DOE/RL-89-03
Revision 3

Hanford Facility Dangerous Waste Permit Application, 616 Nonradioactive Dangerous Waste Storage Facility

Date Published
March 1997

FROM DRAWING H-6-1559 SHEET 1

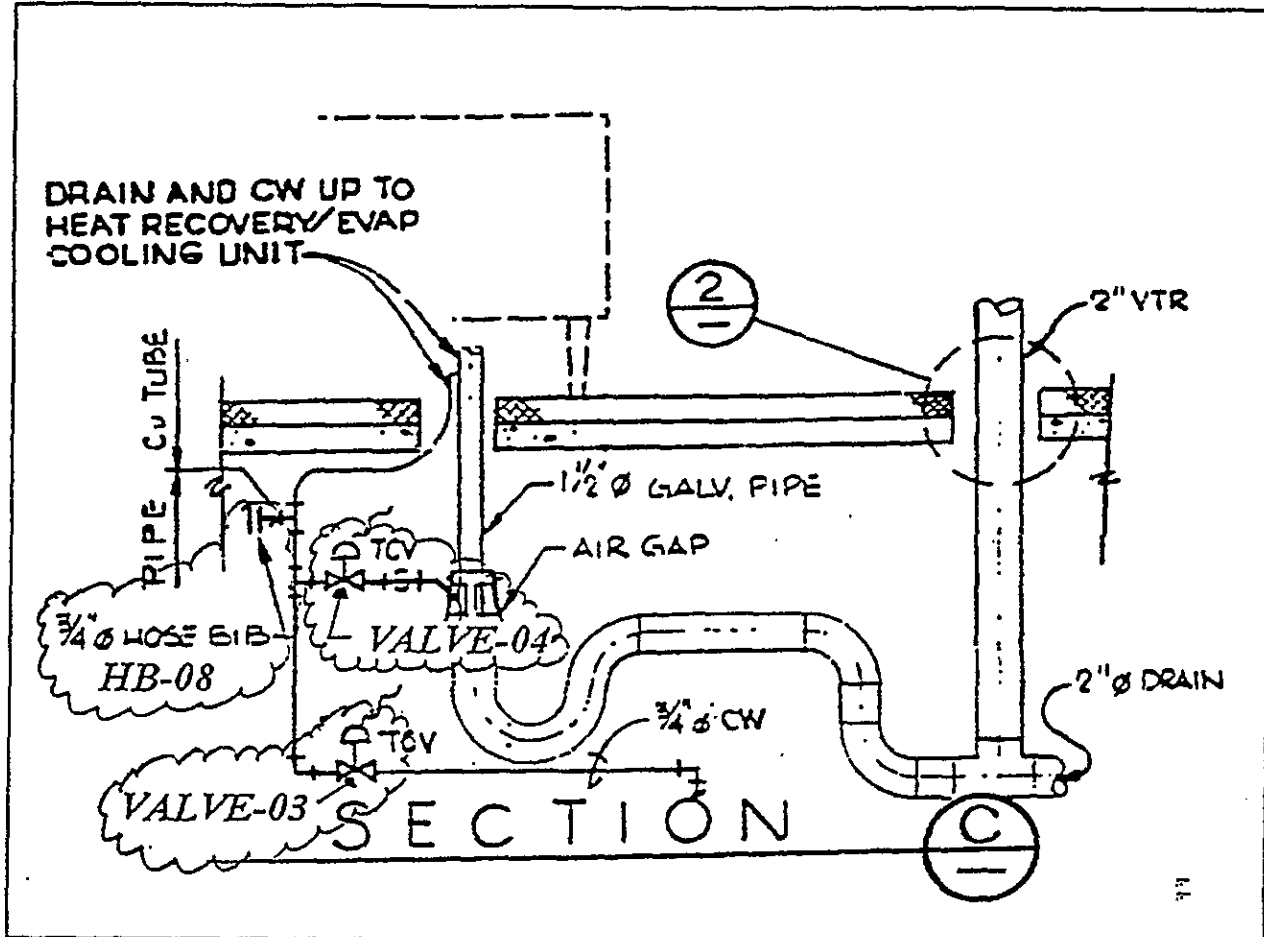
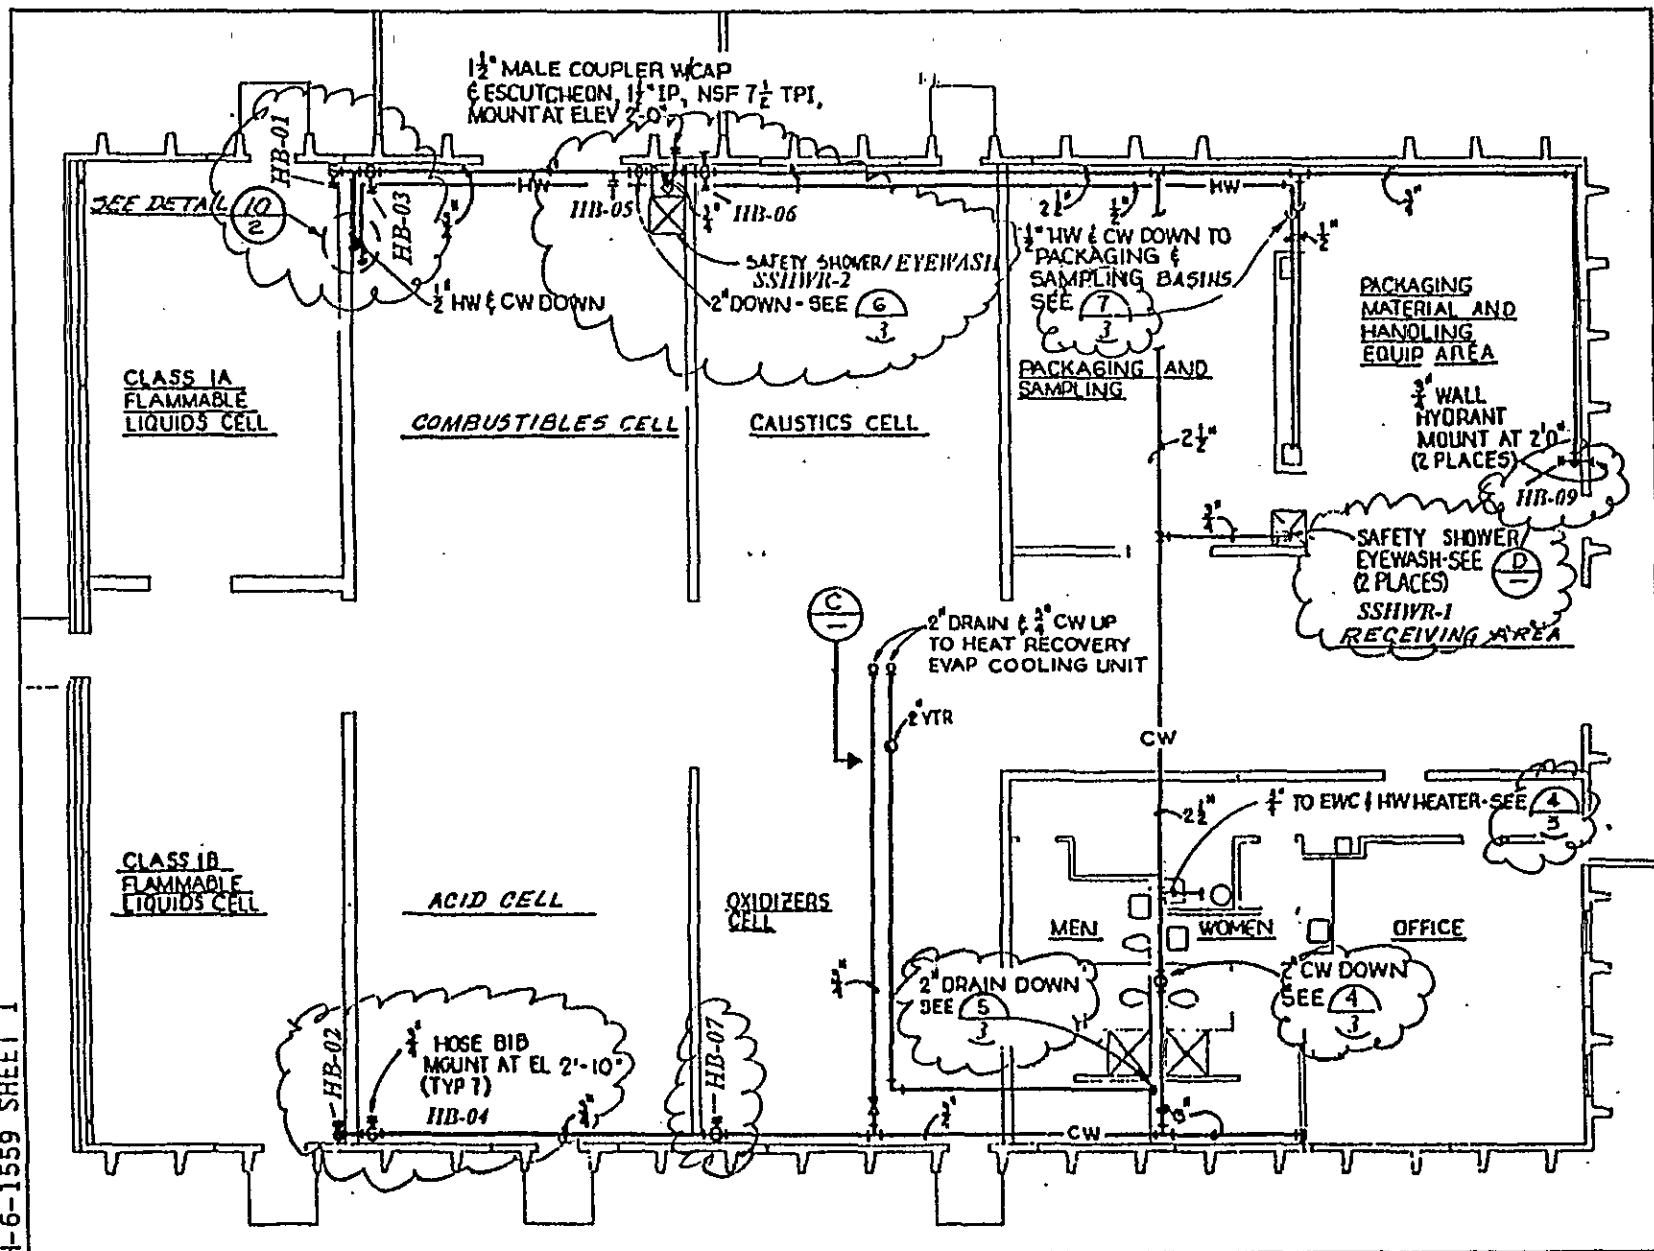
12. Description of Change Block 8 Continued: H-6-1559 Sh. 1 Rev. 4 and Sheet 3 Rev. 1 1: THIS ECN IS TO SUPERSEDE ECN #605641 ENTIRELY. 2: Add valve and hose bib numbers to H-6-1559 SH 1 REV 4 as shown in the clouded areas of sheets 6&7 of this ECN. 3: Add valve numbering to details 4, 6 & 7 on drawing H-6-1559 sh 3 rev 1 per clouded areas on pages 3, 4 & 5 of this ECN 4: Correct Drawing targets on H-6-1559 sheets 1&3 to accurately reflect proper drawing references as indicated in clouded areas on sheets 3, 4, 5 & 7 of this ECN. 5: Add hose bib #5 (HB-05) to H-6-1559 sheet 1 rev 4 as shown on page 7 of this ECN. CONTINUED ON PAGE 3 OF THIS ECN			
13a. Justification (mark one) As-Found <input type="checkbox"/>	Criteria Change <input checked="" type="checkbox"/>	Design Improvement <input type="checkbox"/>	Environmental <input type="checkbox"/>
Facilitate Const. <input type="checkbox"/>	Const. Error/Omission <input type="checkbox"/>	Design Error/Omission <input type="checkbox"/>
